FREDERICK COUNTY PLANNING COMMISSION July 13, 2011

TITLE: Stanford Industrial Park: Section III,

Lot 31

FILE NUMBER: SP 00-12 (AP #11795, APFO #11796

Exhibit #1 Overall Site Plan: Stanford Industrial Park Lot 31

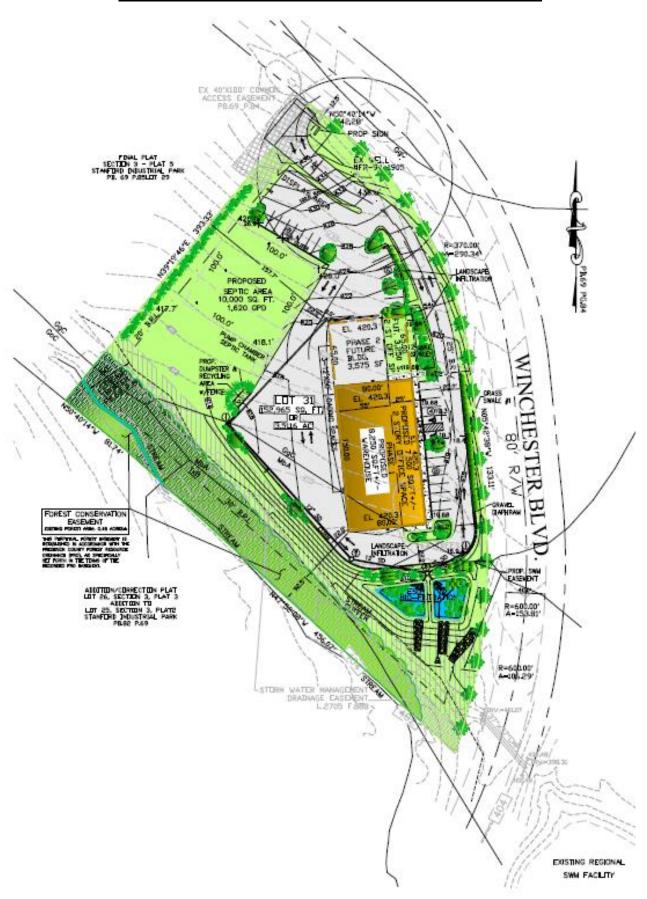
The Applicant is requesting a modification of drive aisle width as noted in Zoning Ordinance Section 1-19-6.220.B.1 (See Exhibit #2). The modification request is to allow a reduction in required aisle width for two-way traffic from 24-feet to 22 feet. This site will not generate a heavy amount of traffic and the proposed parking lot design specifies parking on only one side of the drive aisle. With parking on only one side of the drive aisle, vehicles can back out of the parking spaces without having to compensate for another vehicle parked across the drive aisle. This allows more room for drivers to maneuver their vehicles of the parking stall. The reduced drive aisle width also reduces the amount of impervious cover on site. Staff supports this 2-foot reduction in drive aisle width, because the overall module is consistent with our standard practices for single-loaded parking.

The Applicant has requested a parking space modification in accordance with Zoning Ordinance §1-19-6.220.A. (See Exhibit #3). Staff supports granting this modification request. The Applicant states that the actual parking of the proposed uses of contractor's office, warehouse and sales and service center will be much less than the code requirements. The uses do not generate a large number of customer visits and the proposed uses do not require a large amount of employees; therefore, the additional 20 required spaces would not be used. The Applicant is also trying to eliminate any additional and unnecessary impervious material on site.

The Applicant has shown 3 large (12'x50') loading space to the rear of the principal structure on the site.

<u>Bicycle Parking</u>: The Applicant is required to provide two bicycle racks, the Applicant has complied with this requirement and located the bike racks in front of the principal structure.

<u>Lighting</u>: The Applicant is providing lighting with six building mounted lights, and three, 15' pole lights at locations shown on the plan. The Applicant has noted on the plan that lighting will not exceed 0.5 ft/candles at the periphery of the site and lighting will be directional onto the site through the use of shielding and lighting orientation.

- 1. Address all agency comments as the plan proceeds through completion.
- 2. Note that the FCPC granted the following Applicant requested Zoning Ordinance Modification Requests;[these need to also be part of the motion]
 - a. Zoning Ordinance Section 1-19-6.220.B.1 to reduce the two-way, single loaded drive isle width from 24' to 22'.
 - b. Zoning Ordinance Section 1-19-6.220.A to reduce the required number of parking spaces from 48 to 28.
